|  | PART - GROUP CHANGE NOTIFICATION | | | | Bulletin no | 2011-16 | Date | 01.02.2009 |

TECHNICAL EXPLANATION OF THE CHANGE

| Issue | BAFFLE CHANGE |

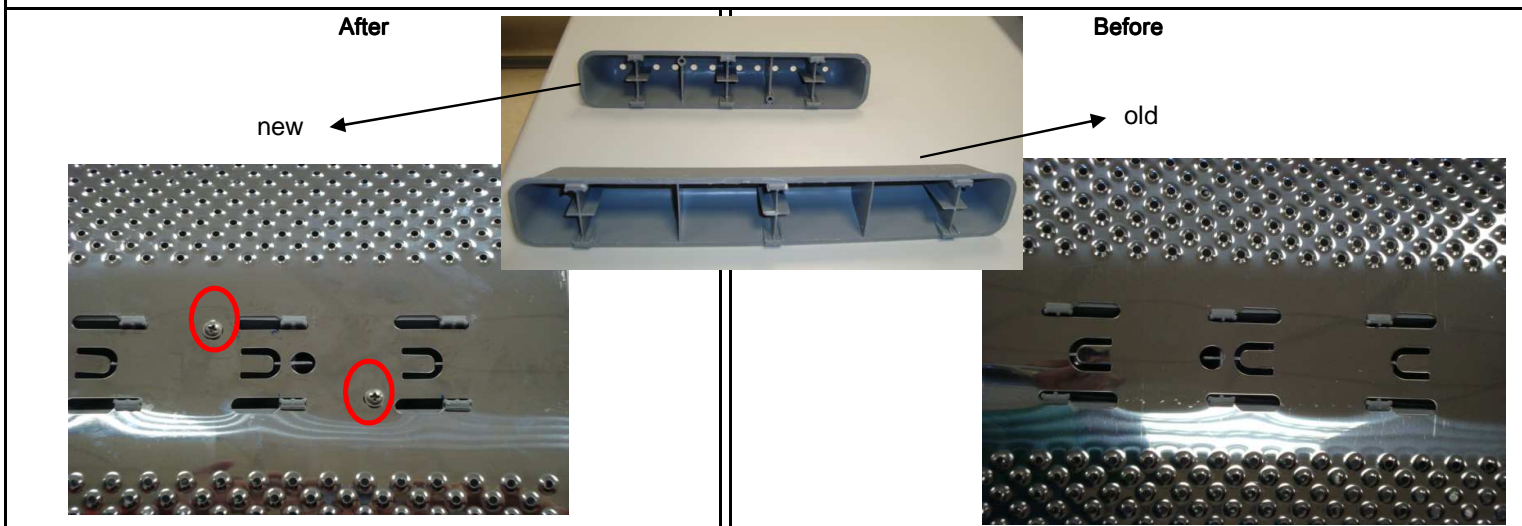
From February 2009 all washing machine baffles are to be fixed to the drum using 2 screws.

If baffles need replacing for the washing machines produced in and after February 2009:

For the models with welded tubs: The tub/drum assembly group will need to be changed.

For other tub types: The baffles can be unscrewed and new baffles can be fixed after disassembling the tub.

For the large models: The baffle used for the rest of the models is used also for these models. By this way all the baffles are unified.

For servicing products produced prior to this date the old baffle (28 1249 03 00) should be used.

New baffles can be used for servicing washing machines produced prior to this date without using screws.

Incorrect straightening method
straightening method

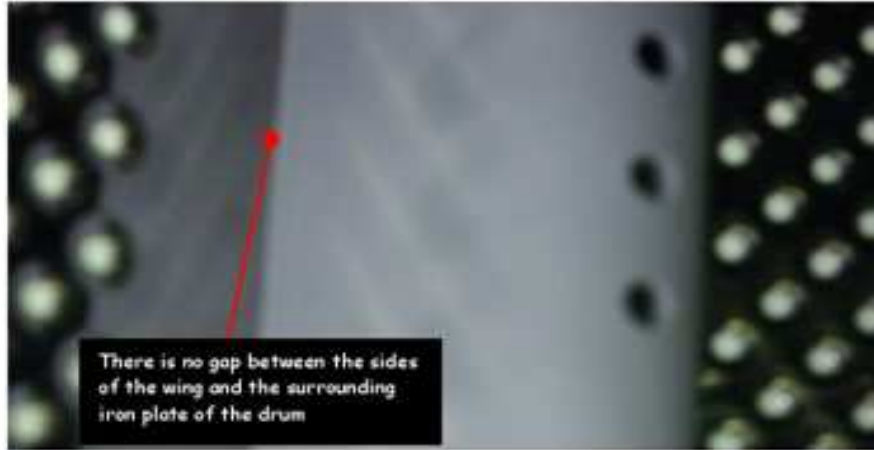
Iron sheet tabs are bent inwards to insert the wing. To do this, a flat-tip screwdriver will be useful. The point to be taken into consideration while flattening the tab is that the tip of the tab should rest appropriately. For this reason, while flattening the tab with one hand with a screwdriver, thumb of the other hand should be used to support the bottom of the tab. Thus, bending process will be carried out both in a controlled way and also appropriately. Forcing the side of the tab to make it straight may cause bending of the tab irregularly.

Correct

- The wing is passed through the wide slot area which has been created to pass the plastic tabs and it is pulled forwards (towards the mouth of the drum) to ensure passing of the iron sheet tabs. When the iron sheet tabs are seated behind the wing's stopper feather, a "click" sound will be heard. At the end of the mounting process, there should be no gap between the sides of the wing and the surrounding iron plate of the drum.

- To check if the mounting is made correctly, the wing is forced backwards and sidewards. If it does not come out or if it does not move too much, the mounting is completed.
